RE: Project Solis
Mesa Del Sol Innovation Park II, TRACT J
Conceptual Grading & Drainage Plan
Engineer's Stamp Date: 9/19/2025
Hydrology File: R16DA1001
Case #: HYDR-2025-00339

CONCEPTUAL DRAINAGE PLAN

C801

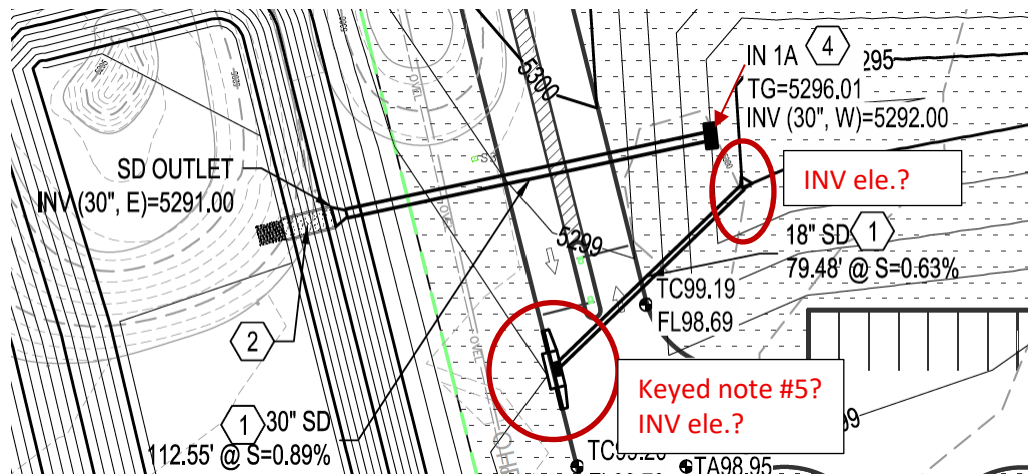
Please provide details on the 18" & 30" SD at the NW corner in the next Grading & Drainage plan.
